CITY OF NOVI CITY COUNCIL JUNE 7, 2021

SUBJECT: Consideration of approval of Change Order No. 5 to Florence Cement Company for the Cranbrooke Road reconstruction, 9 Mile Road to Village Wood Road, sidewalk addition in the amount of \$104,196.85.

WORK CHANGE DIRECTIVE & CHANGE ORDER No.

5

Cranbrooke Drive Sidewalk Location Map

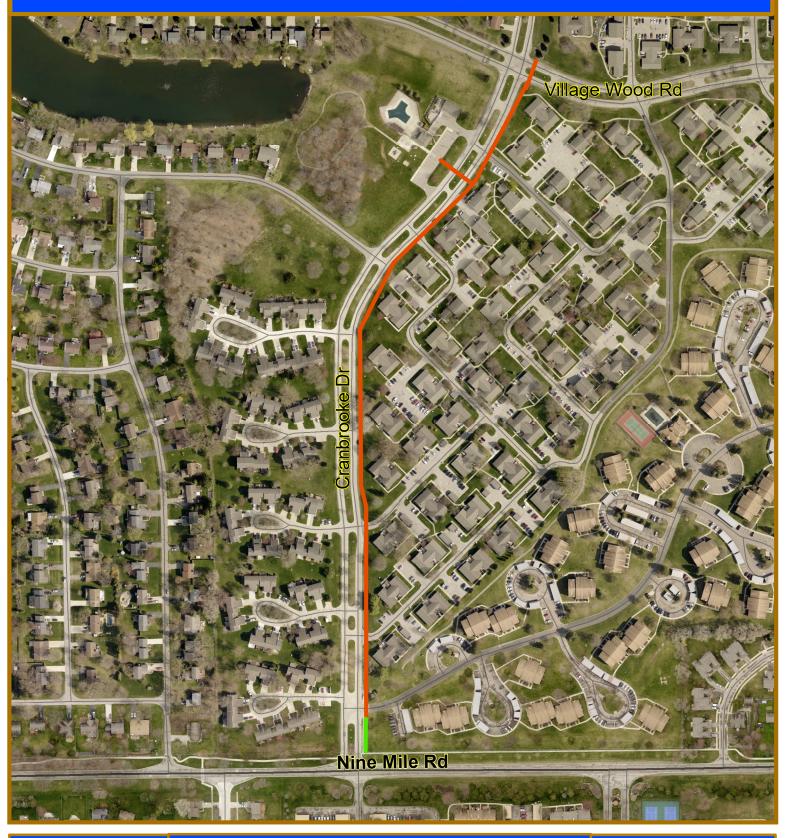
BACKGROUND INFORMATION: At the April 12, 2021 City Council meeting, it was recommended by City Council that staff investigate the cost of adding sidewalk to the Cranbrooke Road reconstruction project scheduled for summer of 2021. This segment of Cranbrooke Road currently sees a lot of pedestrians sharing the roadway with vehicles.

City consultant AECOM provided an estimate and design for the sidewalk. The contractor for the road project, Florence Cement Company, submitted unit prices for a change order to their original contract for the sidewalk, which were lower than AECOM's estimate. Consequently, City staff recommend the sidewalk be added to the road reconstruction project, which is scheduled to start on July 5, 2021.
